**WOODLAND CREATION SCHEME
EAST NETHERSHIELDS
A723
STRATHAVEN**

ROAD SAFETY REVIEW
(SPA Ref No: 5349)

Roads Authority: South Lanarkshire Council

Client: Tilhill Forestry

3.2 Accident Location

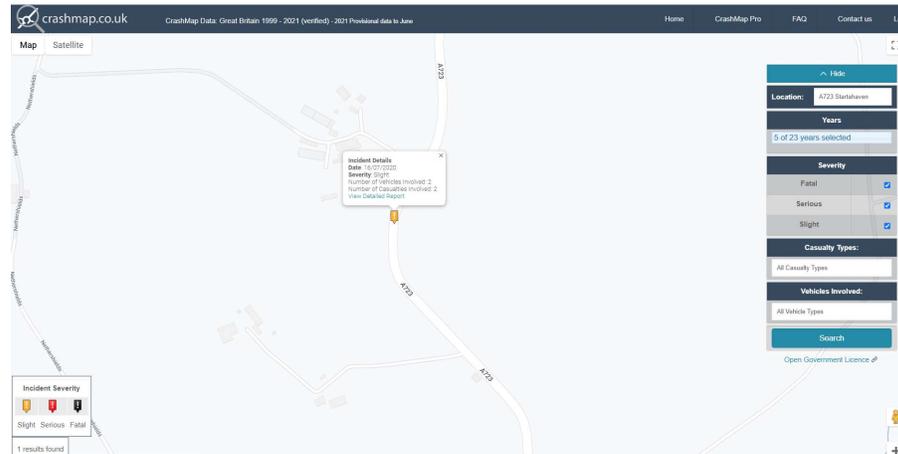
3.3.3 The description of the collision and the damage to the vehicles would indicate that one of the vehicles may have been on the wrong side of the carriageway or has lost control while negotiating the series of bends. There is nothing to indicate that any of the existing junctions or visibility issues were a causation factor in the collision.

Fig 3.9

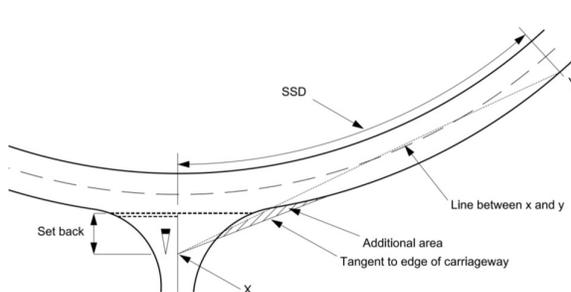
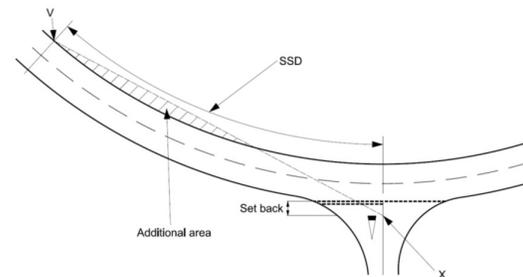
The three existing access junctions on the A723, namely Nethersields North, Nethersields South and South Shields are built to differing standards. All three junctions rely on visibility splays which cross adjacent fields. The presence of existing verges, hedges, fencing along with the vertical and horizontal alignment of the carriageway results in visibility splays which are more than likely less than the, 215m DMRB standard, which would normally be expected.

All three junctions lie on the outside of curves and accordingly the visibility splay may have to be constructed as a combination of the guidance outlined in CD123 'Geometric design of at-grade priority and signal-controlled junctions', Figure 3.9 and 3.10.

The access junction on Burn Road is located a straight section of carriageway although visibility is restricted due to the existing hedgerows and a crest to the east of the access.

Areas of verges identified when constructing the visibility splays will be required to be kept clear of tree planting and it may be necessary to prune existing hedgerows.

It is recommended that when designing the final tree line of the woodland creation scheme that all planting is kept clear of visibility splays. The guidance provided in DMRB, CD123 'Geometric design of at-grade priority and signal-controlled junctions' should be followed.
